STAFF REPORT

SUBJECT: George Hotel and Residences – Horizon Engineering response to peer reviews

Re: Proposed "The George" Mixed Use Development
377, 385 & 407 Gower Point Road, 397 & 689 Winn Road, and Winn Road Right-of-Way,
Gibsons, BC
Memorandum Regarding Geotechnical Review Report

Re: Proposed "The George" Mixed Use Development
377, 385 & 407 Gower Point Road, 397 & 689 Winn Road, and Winn Road Right-of-Way,
Gibsons, BC
Memorandum Regarding Hydrogeological Review Report

COMPUTER MODELLING
Hydraulic Gradient
Results

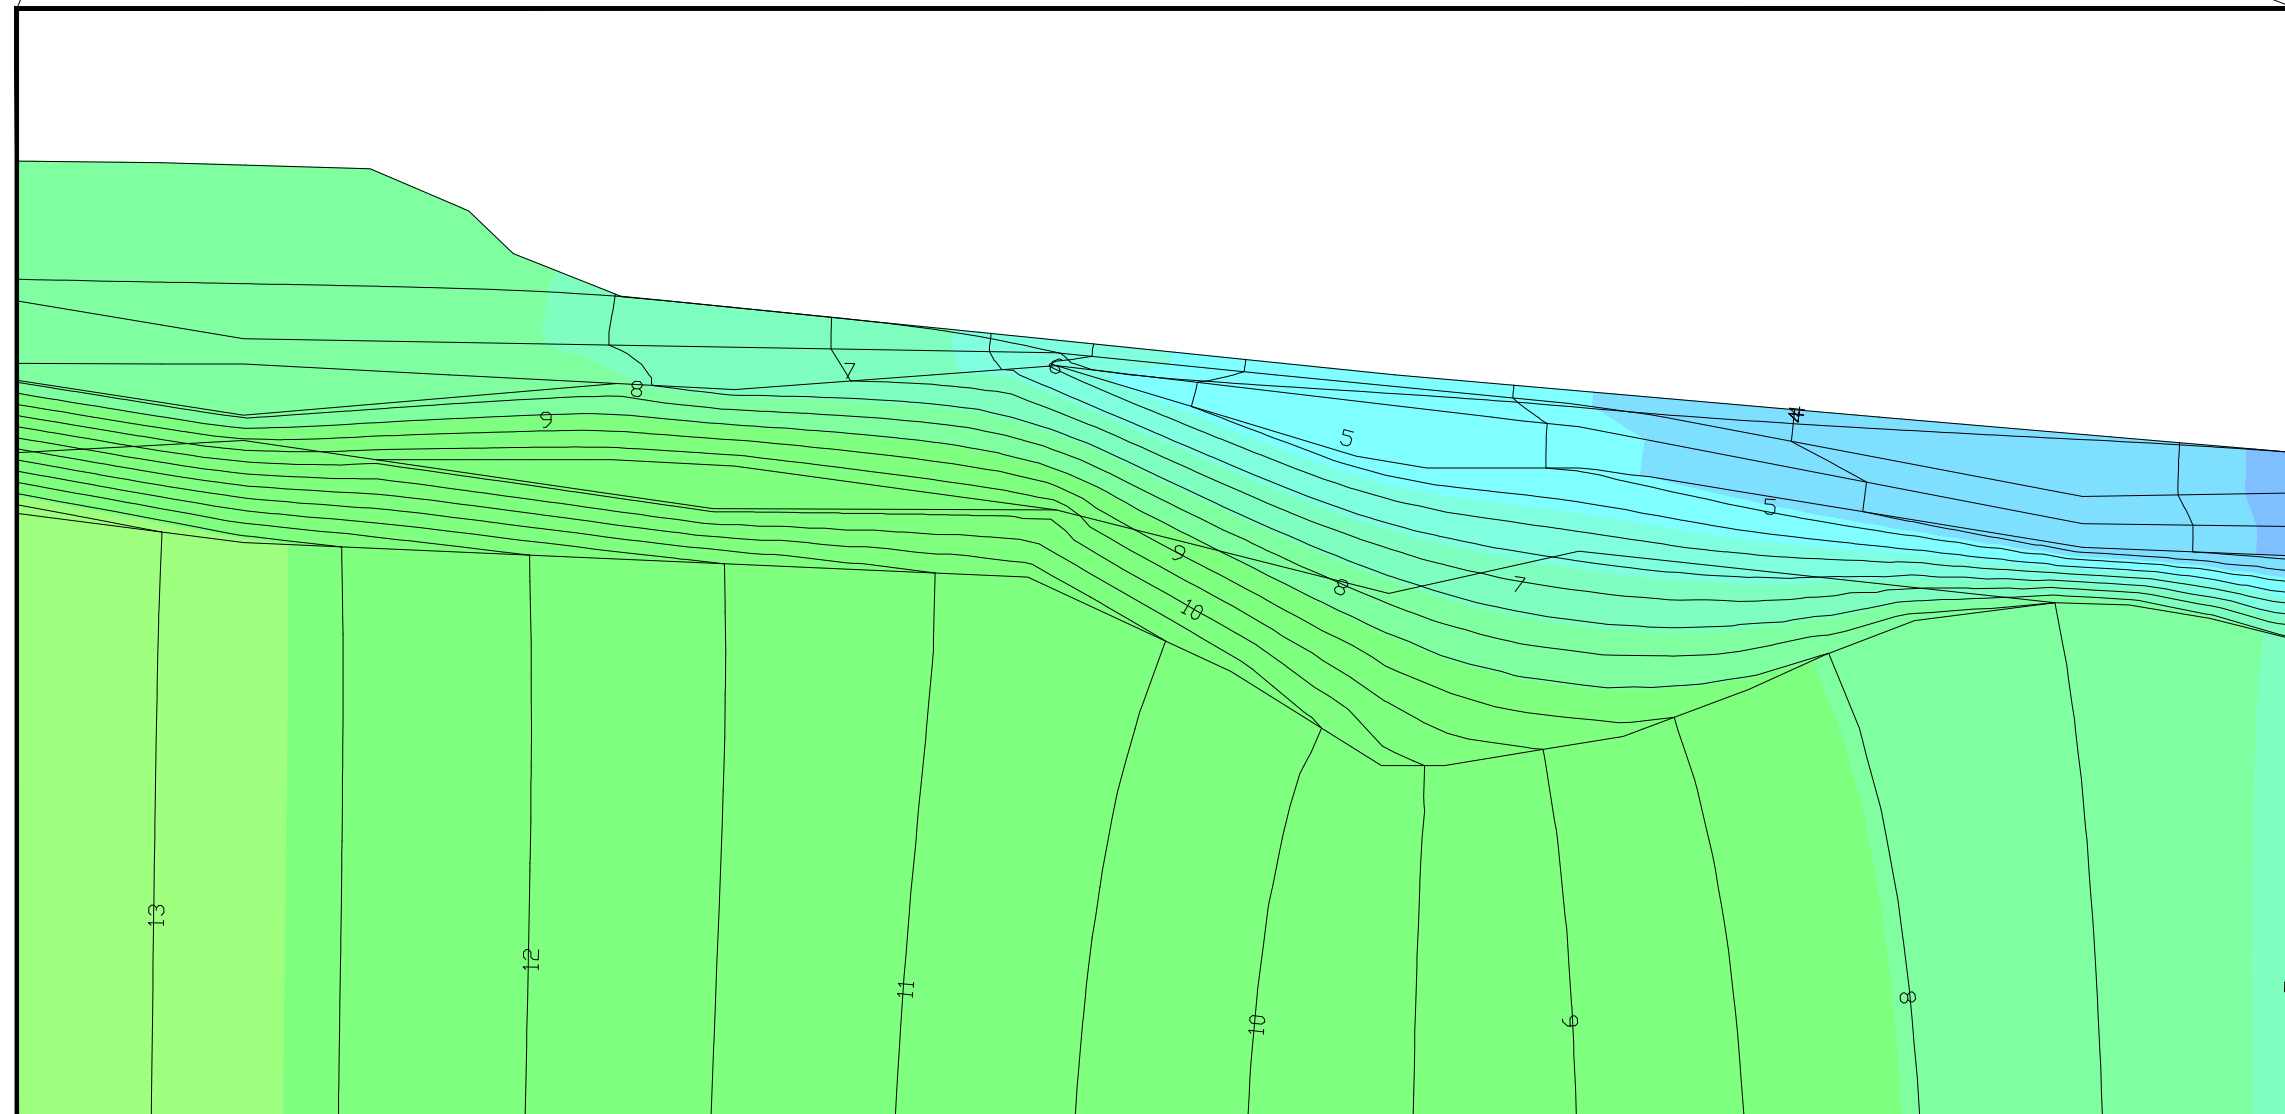
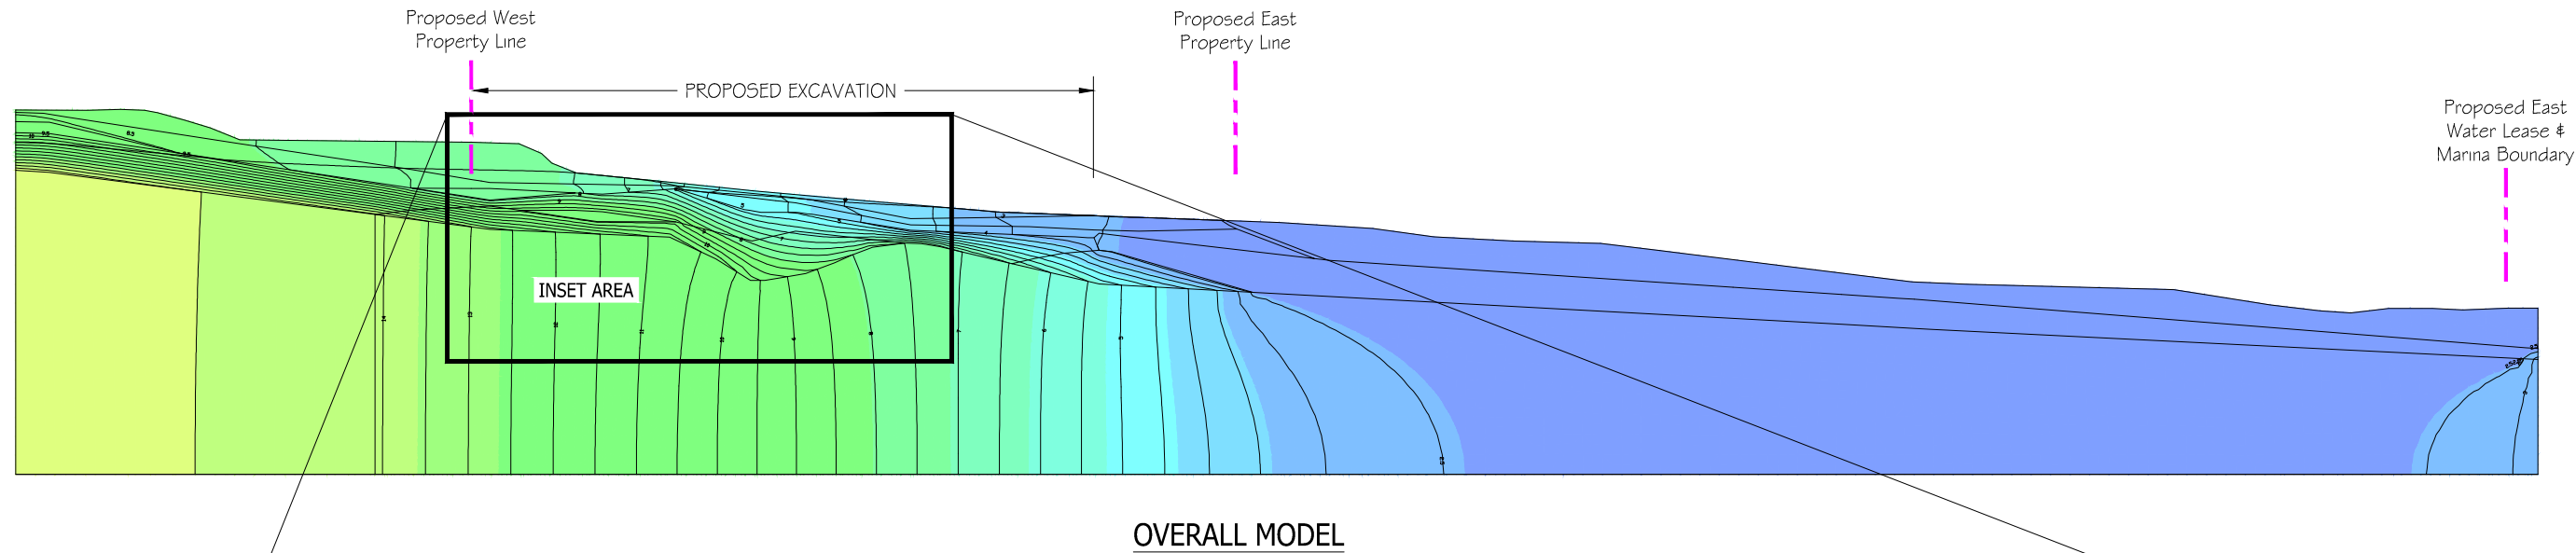
Vertical hydraulic gradients were considered during the computer modelling work that is described in Section 8.0 of our report. Upward artesian water pressures within the Gibsons Aquifer were analyzed in order to estimate changes in subsurface stress conditions as excavation progresses and to determine the magnitudes of potential ground movements at each stage. This modelling work has been revisited since the April 7, 2015 report was issued, as discussed in our memorandum regarding the hydrogeological review report. For information, a print out of the calculated upward hydraulic gradient where the excavation for the P2 parking level is proposed is attached to this document.

Based on the above, as well as on the discussion above regarding Paragraph 5, we do not envisage that truncation of the P2 parkade level is required, as was suggested in Levelton's report.
